UPDATE SHEET

PLANNING COMMITTEE – 01 December 2015

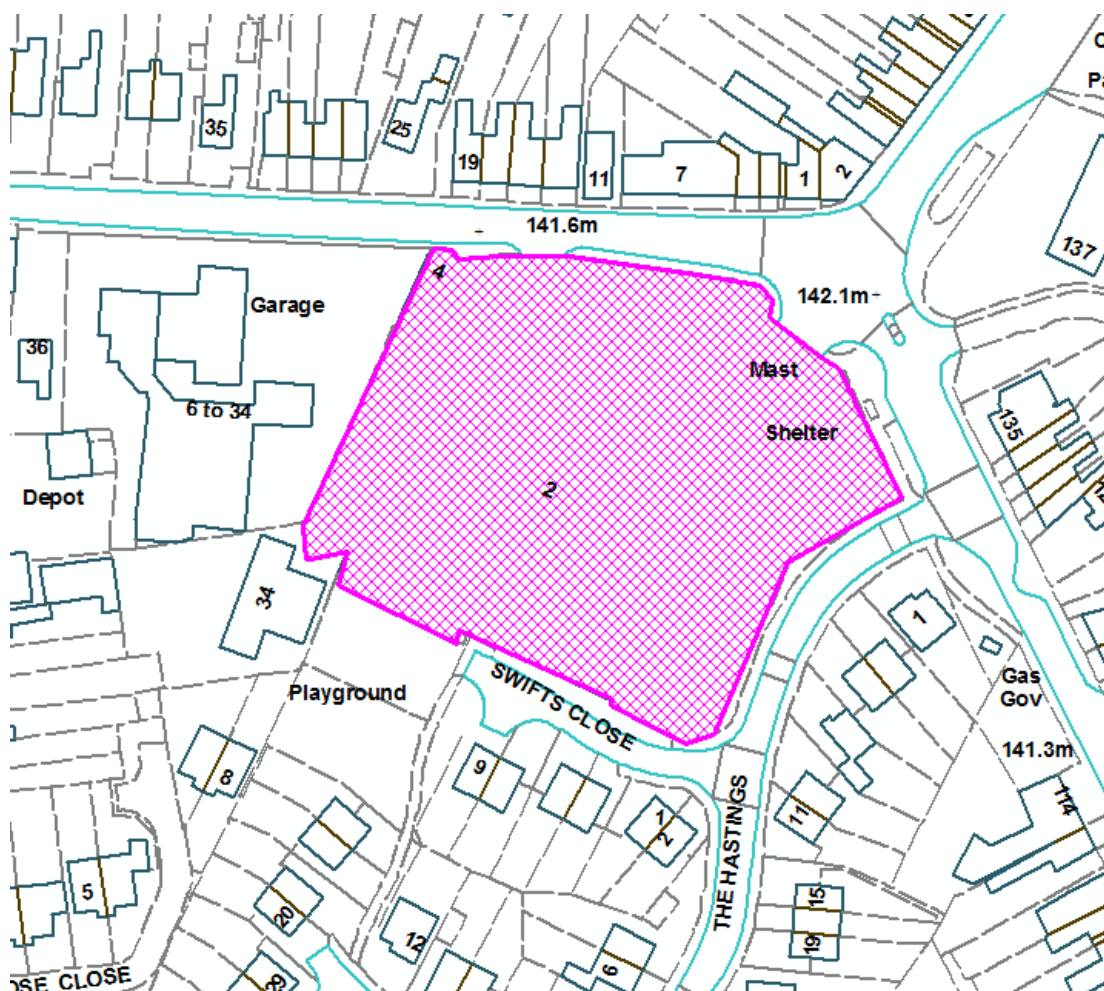
The indicative map provided on page 45 of the Committee Report is incorrect as it does not include the residential property which is proposed to be demolished. An accurate site location plan is provided below:
